# Key Components, Tegholmen Works

## MC fuel pump

Service Letter

**Fuel Pump Top Cover**  
**L/S35MC, S46-50-60-70MC-C**  
**(Fuel pumps without VIT)**  
Action Code: AT FIRST OPPORTUNITY

# Latest Design for 80-98 bore MC/-C engines

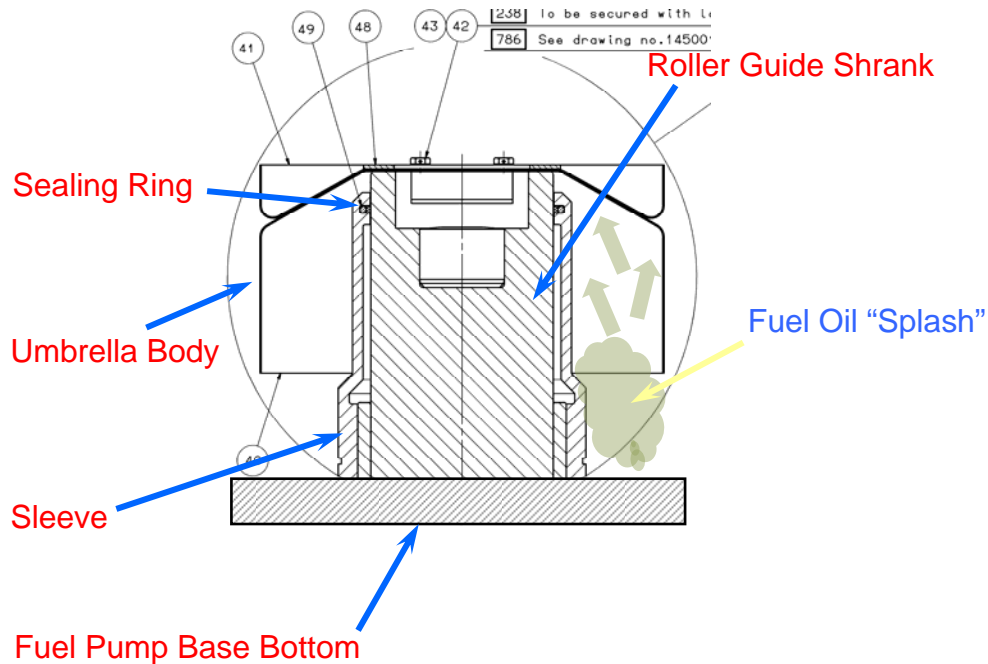
Fuel on lower surface of umbrella caused by splash from pump base bottom

Leaking fuel oil from the plunger/barrel assembly enters the fuel pump base bottom. Pressure variation within the pump base block during up and downwards movement of the umbrella lead to splash of fuel oil as indicated

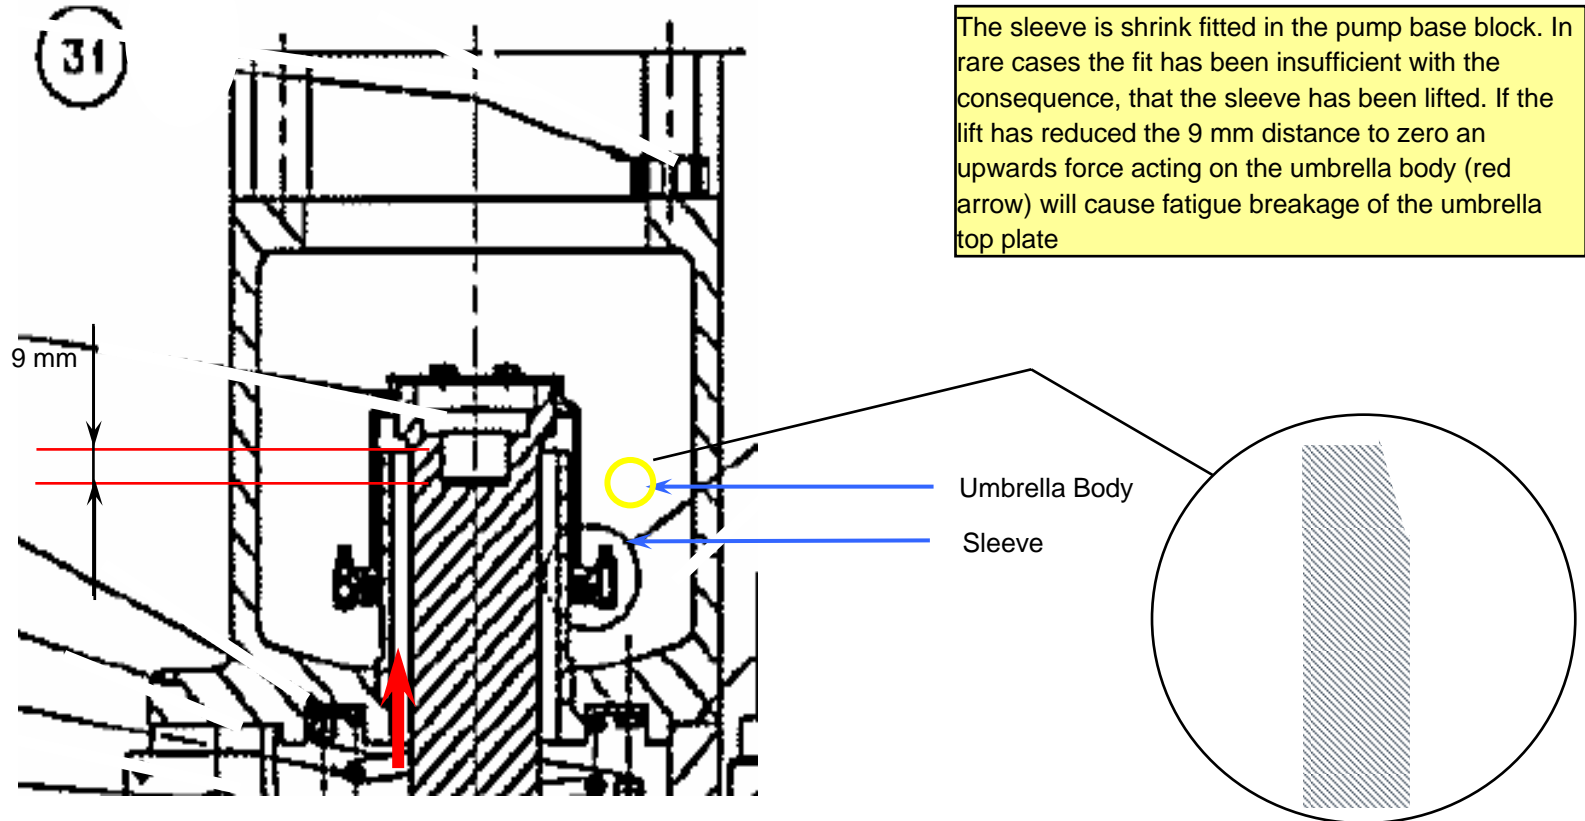
The sleeve is shrink fitted in the pump base block. In rare cases the fit has been insufficient with the consequence, that the sleeve has been lifted. If the lift has reduced the 9 mm distance to zero an upwards force acting on the umbrella body (red arrow) will cause fatigue breakage of the umbrella top plate

The taper shape of the top of the sleeve was insufficient to prevent damage to the sealing ring edges during assembly

## Latest Umbrella Design

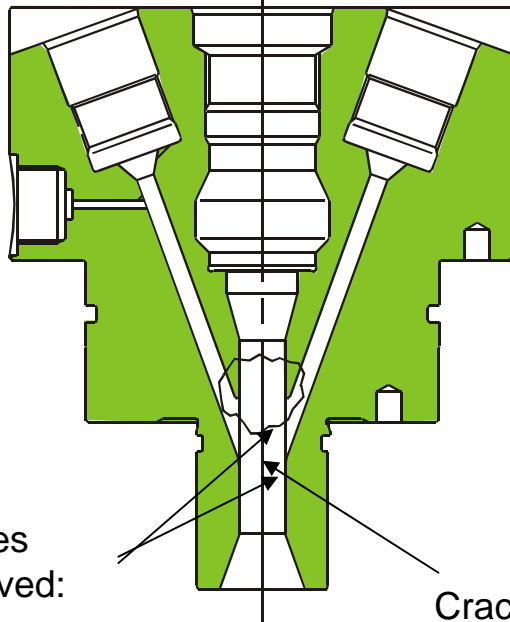
- Consider introduction of holes in vertical umbrella parts where through the pulsation of air can equalize. This may stop the fuel splash.

SL02-412

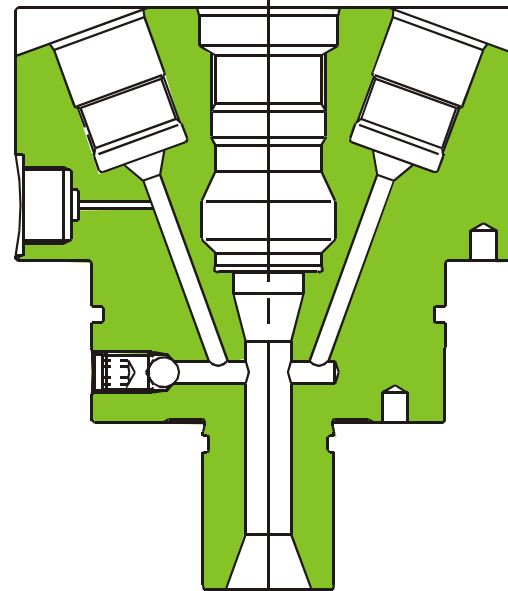
Sharp edges  
to be removed:  
R1-R10

Crack initiation area

The fractures have been experienced on small and medium bore engines. The fractures were initiated at the position where the inclined drillings for the high-pressure pipes intersect with the central bore. The cause of the failure has in all cases been related to roundings which did not fulfil our specifications.

# Fuel pump suction and puncture valve combined

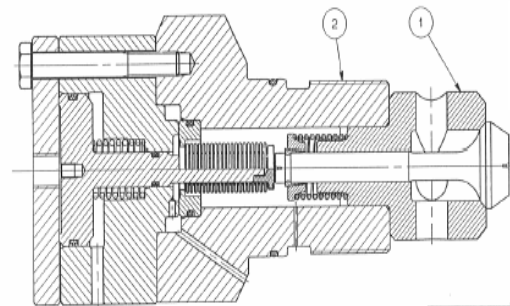
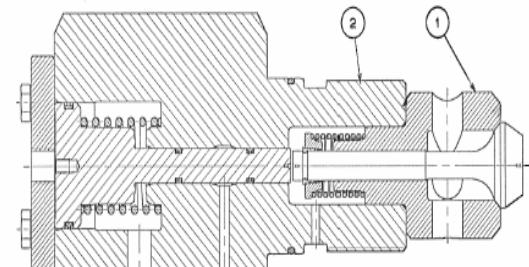
Due to cracked bellows, the design has been changed.

Previous design with bellows

Modified design w/o bellows

Unit item 2 from modified design is interchangeable with unit item 2 from previous design.

Modified according to SL97-344

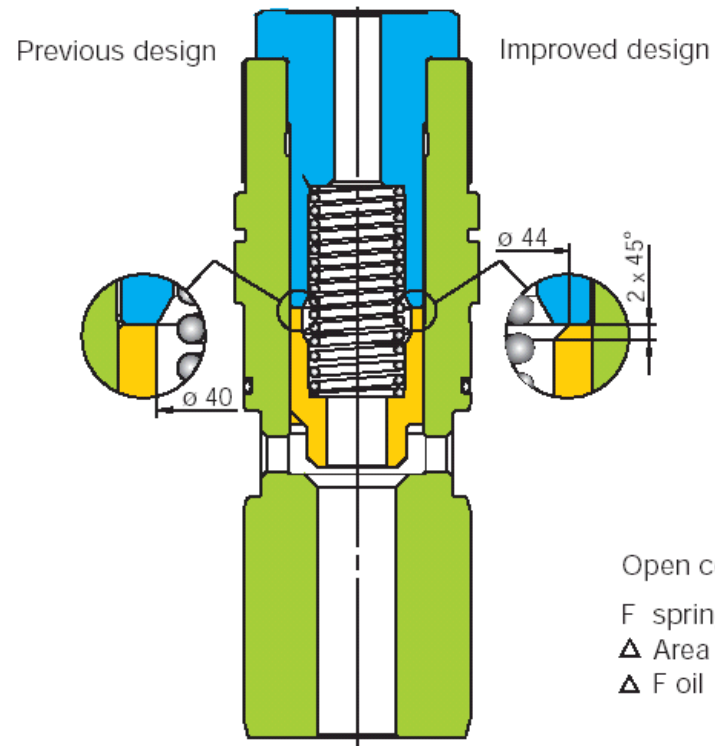
Slide without groove and sealing ring  
and with reduced clearance.

And where the slide again has been  
modified with a chamfering to ensure  
proper functioning irrespective of the fuel quality.

Always ensure to use the latest design.

ENCLOSURE 1

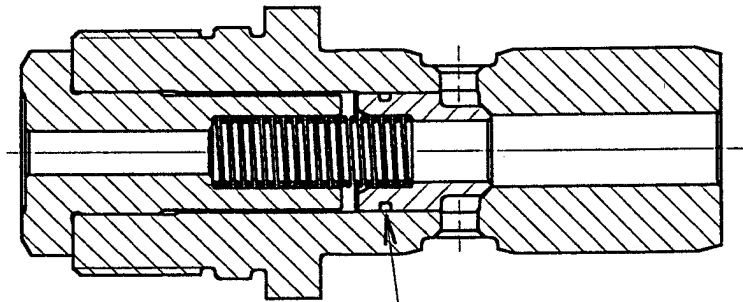
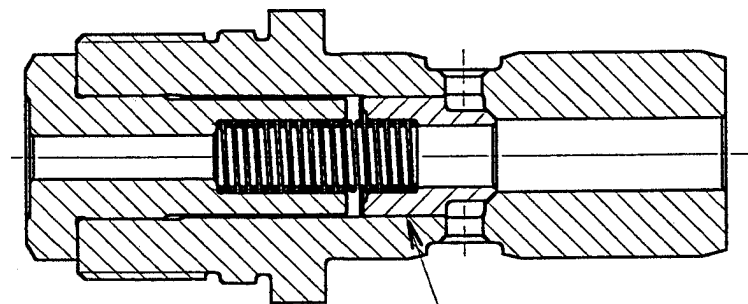
ORIGINAL SUCTION VALVE  
FOR Mk 3 & 5 FUEL PUMP  
WITHOUT UMBRELLA

SEALING RING TO BE REMOVED  
ON ENGINES IN SERVICE

NEW SUCTION VALVE  
FOR Mk 3 & 5 FUEL PUMP  
WITHOUT UMBRELLA

SLIDE WITHOUT GROOVE  
AND WITH REDUCED CLEARANCE

As for future spare parts deliveries, this suction valve slide will be specified without the sealing ring groove, and with a slightly reduced clearance between the slide and the valve housing, please see Enclosure 1.

S90-K98MC/MC-C

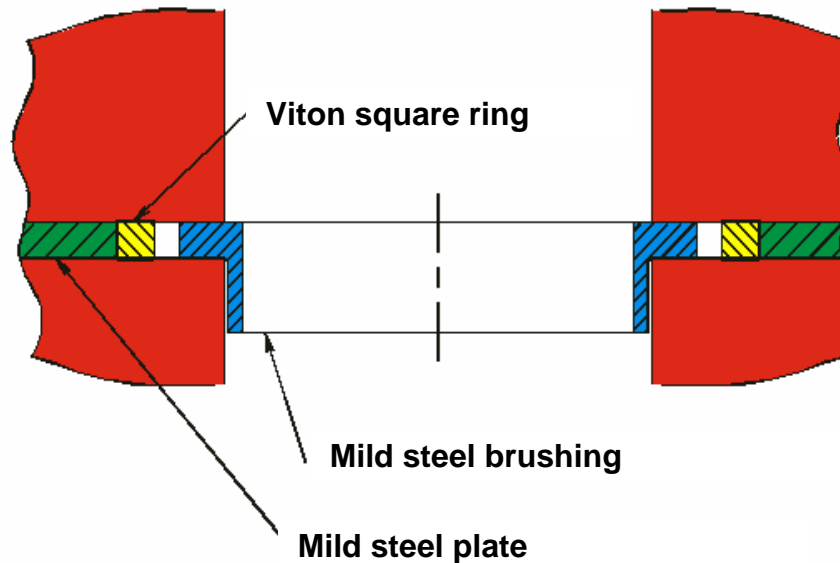
The previous fibre packing has been modified and is fully interchangeable with the above mentioned unit.

Afterwards only Viton square ring has to be changed.

## 'Umbrella' roller guide for fuel pump (K98MC-C and K98MC engines)

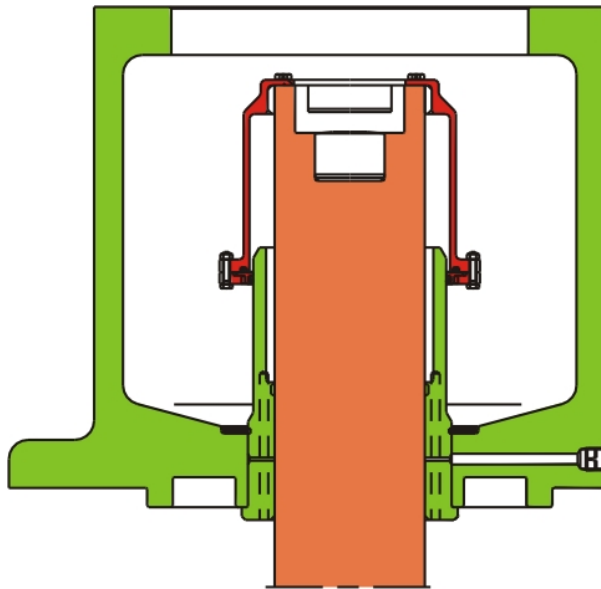
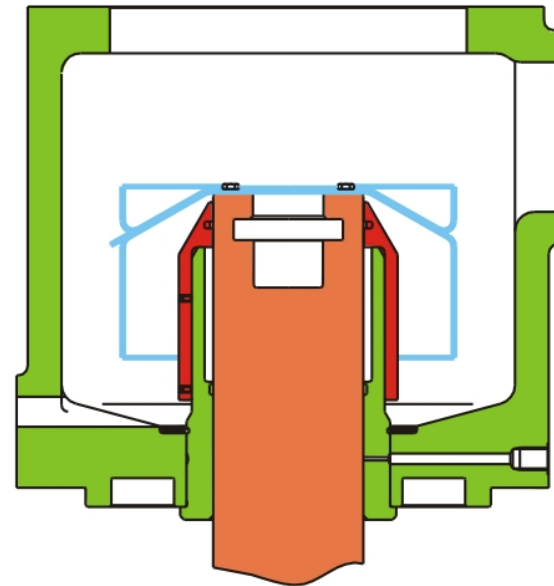
Previous design

New design

## 50-90 cm bore MC and MCE engines K/L45-55-67-80-80GB/GF/GFC/GFCA

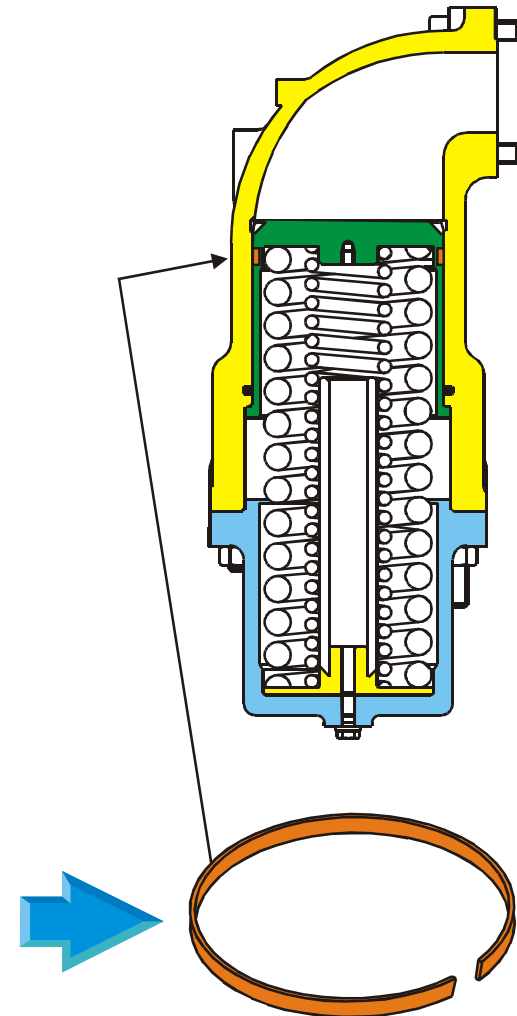
In a few cases cracks have appeared in the sealing ring groove of the housing

In certain cases the guide ring acts as a tight sealing ring because the high running temperature reduces the ring gap to almost nothing

A pressure of approx. ten times the normal working pressure is then built up, hence causing the cracks

The problem was solved by exchanging the guide ring with a new ring with larger gap

Figure B

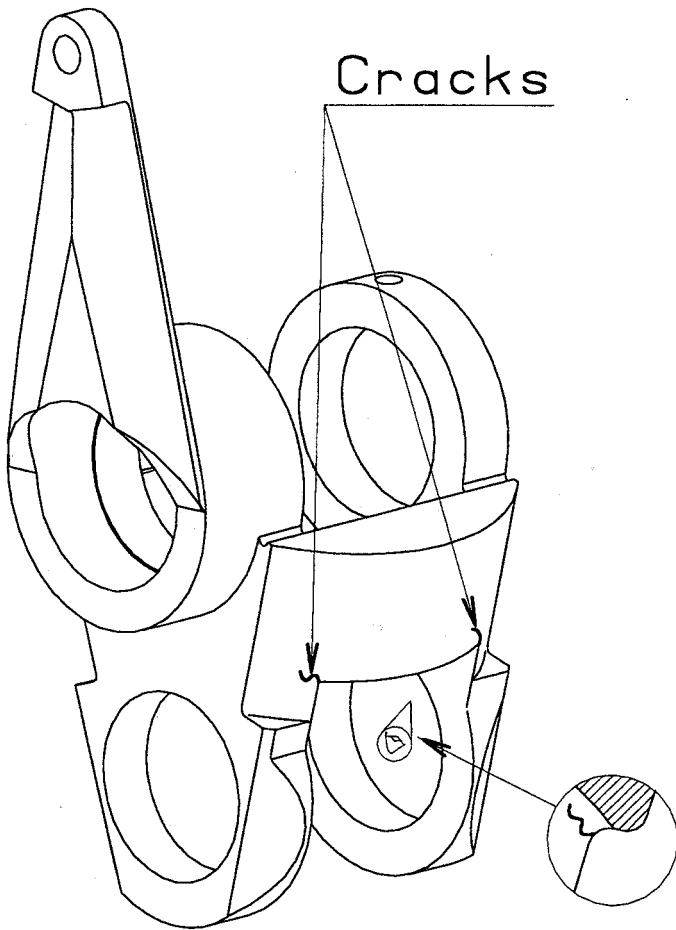
The cracks as shown in Fig. B have mainly been found on the K90MC/MC-C types, Mark V or VI, and they were found after a relatively short time in service. The type of cracks indicated in Fig. A have only been reported in a few cases.

The cracks in Fig. B have primarily been located on the camshaft side and can be detected through the inspection cover in the camshaft housing. We recommend that, as a general precaution, you instruct your crews to inspect the reversing link at the first opportunity.

If cracks are detected, we ask you to make a sketch of the extent of the cracks and forward it to the engine builder or MAN B&W Diesel, Copenhagen and, at the same time, to order replacement reversing links. The new reversing links are modified with larger roundings in the relevant areas.

Figure A

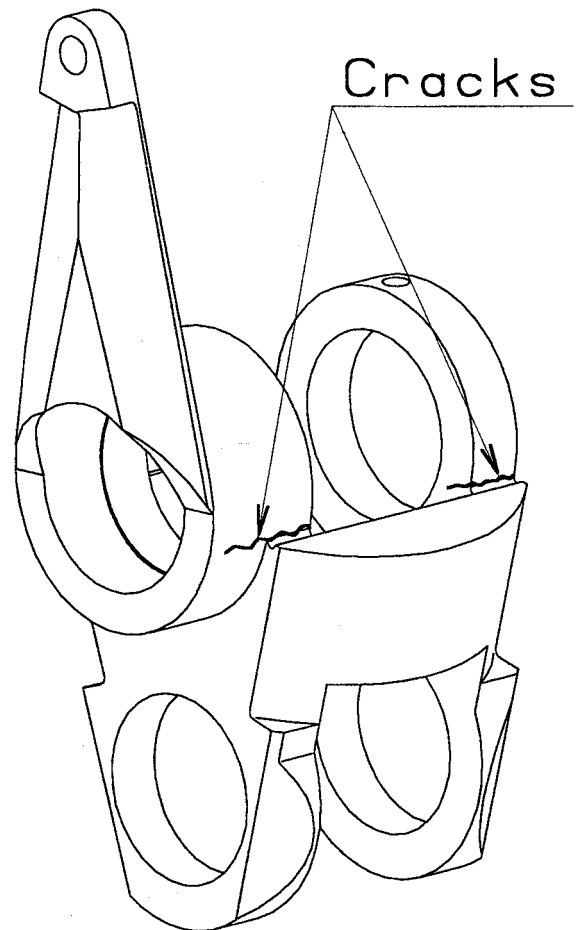
Even if no cracks as shown in Fig. B are detected, it is still recommended to inspect for the types of cracks shown in Fig. A, when convenient. It is necessary to pull out the roller guide in order to do this.

**Checking and changing screws at fuel pump guide block**

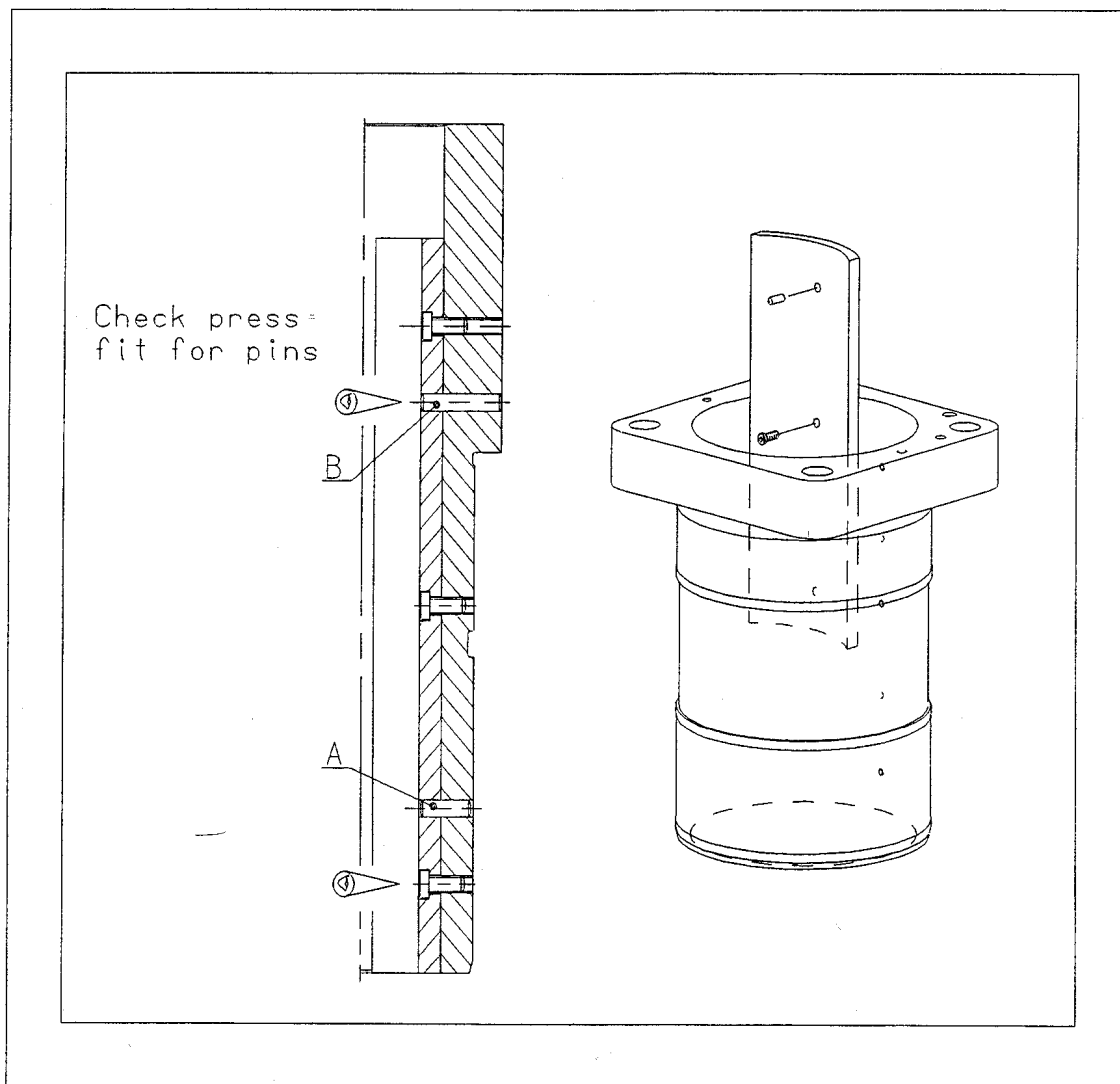
Furthermore, we want to draw your attention to another subject which should be considered in connection with the above recommended inspection of the reversing links. We have received a few reports regarding loose guide blocks for the fuel pump roller guide, see Enclosure 2. Therefore, when checking for cracks in the reversing link, we recommend that also the guide blocks are checked at the same time to see whether they are loose. This can be done when pulling the roller guide.

To improve the fixing of the guide blocks, it must be ensured that the guide pins are inserted in the holes with a tight fit. Furthermore, when new screws are mounted, these should be tightened to the torque indicated in Encl. 2, and locked with Loctite. The new screws should not be locked by caulking, as hitting the screw head improperly, could lead to a reduction of the tightening force of the screw.

1. Dismantle the old screws.
2. Check that the dowel pins are not damaged. If they are damaged, re-check the alignment of the guide block.
3. Check that it is possible for the new screw to seat properly in the old hole in the guide block.
4. Mount the new screws after soaking their threads with Loctite 222. **Note:** It is necessary to degrease the threads.
5. Mount the screws, starting with the lowermost screw.
6. After tightening the top screw, retighten all the screws to the specified torque.
7. Tightening torque: *See enclosed table, Enclosure 2.*

**Note: The guide block must not be caulked after tightening.**
